APPLICATION NO.	FILING DATE	FIRST NAMED INVENTOR	ATTORNEY DOCKET NO.	CONFIRMATION NO.
10/787,124	02/27/2004	Thomas E. Still	12007-0040	4684

Office Action Summary	Application No. 10/787,124	Applicant(s) STILL, THOMAS E.	
	Examiner Sean M. Michalski	Art Unit 3725

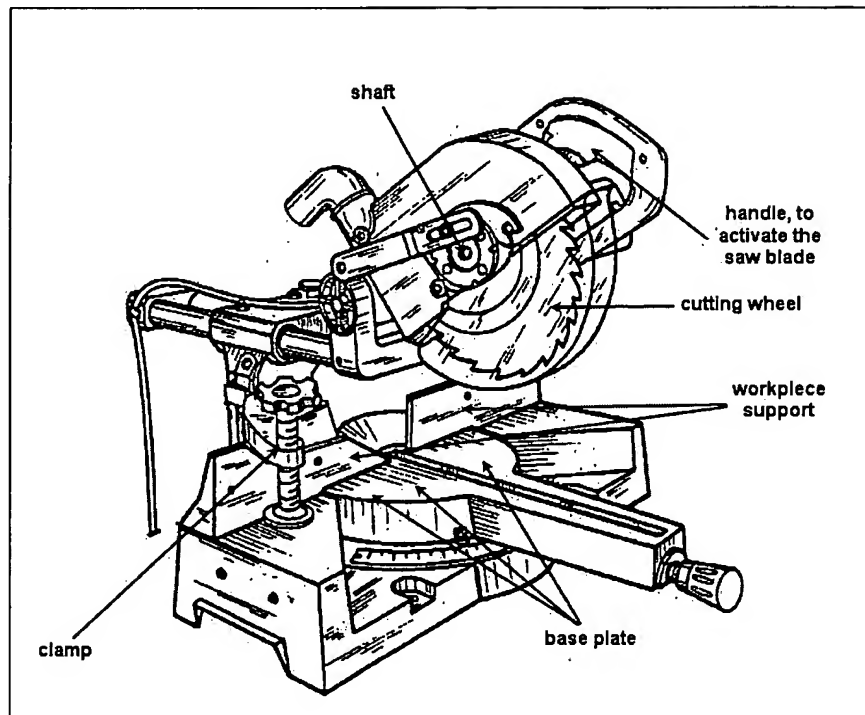
26. Regarding claim 1, Arehart discloses a cutting device, capable of cutting plastic horseshoes, comprising a base plate which bears a shaft the shaft carrying a cutting

wheel adjacent to a workpiece support. The handle activates the shaft and cutting. See commented figure below.

27. Regarding claim 17, Arehart discloses that the workpiece holder has a clamp (seen above), which is a fixing means.
